MEMORANDUM

DATE: September 25, 2020

RE: **#88-20 Discussion and review relative to the draft Zoning Ordinance**
DIRECTOR OF PLANNING requesting review, discussion, and direction relative to the draft Zoning Ordinance.
Other docket items to be taken up within the context of Zoning Redesign include #30-20, #38-20, and #148-20

Attachment D
3.4 Garage Design Standards

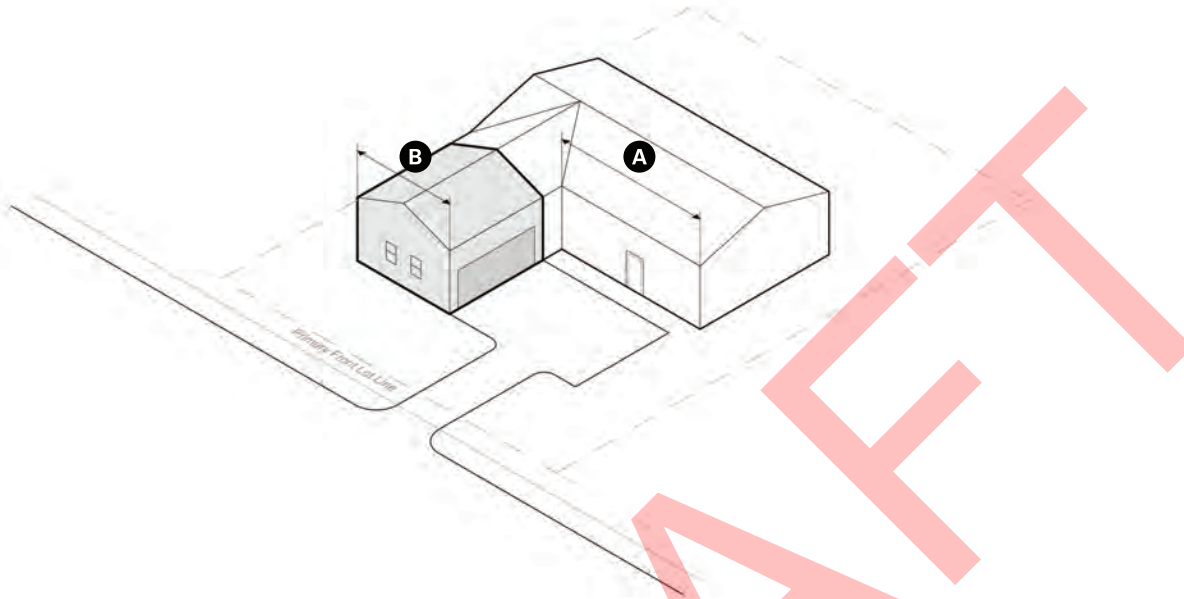
Q: Section 3.4.2.D claims that a garage set back 10' from front elevation and may not exceed 50% of the building front. This is good design practice when the front door takes precedence. How was 10' chosen? Is this a standard?

A: The latest draft recommends that a Front Facing Garage be set back a minimum of 8 ft from the Front Elevation (Sec. 3.4.2.D.a), which aligns with the standard requirements for the Side Wing Building Component. This is not a standard per se. The requirement to offset the garage from the Front Elevation of the building is to limit the visual impact. This recommendation was reviewed by the local architects and builders group.

Lot with eight residential units or less

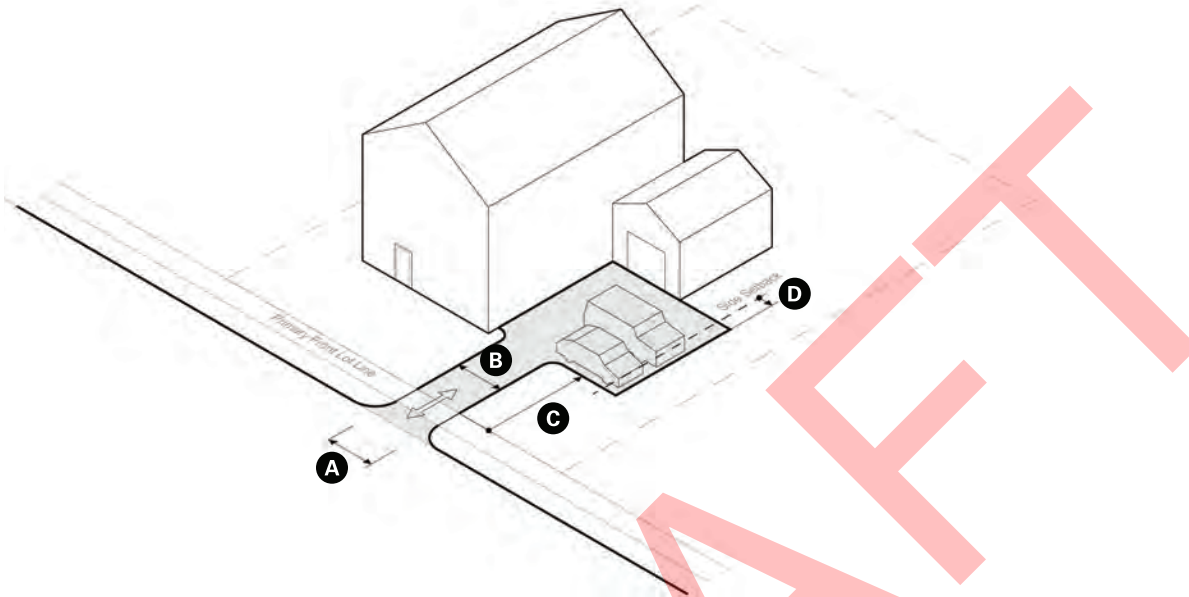
Q: My understanding is that you are recommending that the entrance to a driveway be no greater than 10 feet at the entrance and that this 10 foot width be extended 10 feet into the property from the edge of the sidewalk nearest the property line. Is that correct?

Q: Section 3.7.1.E.7 says that 2 curb cuts have to be 35’ away from each other. Where did the number 35’ come from? Is this a standard?

A: The latest draft recommends that one-way driveways be restricted to a maximum of 10 feet at the property line and for 10 feet beyond the property line into the site for properties in the R1 and R2 districts. Because of the smaller front setback requirements in R3, R4, and N the proposed distance is reduced to 5 feet beyond the property line. The property line does always correspond to the edge of the sidewalk. The curb cut is restricted to a maximum of 12 feet for one way-driveways.

A: Note: In the latest draft this refers to Sec. 3.7.1.E.8. The 35-foot distance between two curb cuts was provided by our consultant and reviewed by ISD and Engineering. 35 feet allows for two standard cars to be parked between the two curb cuts and it provides a sizeable “safe zone” for pedestrians between each curb cut.
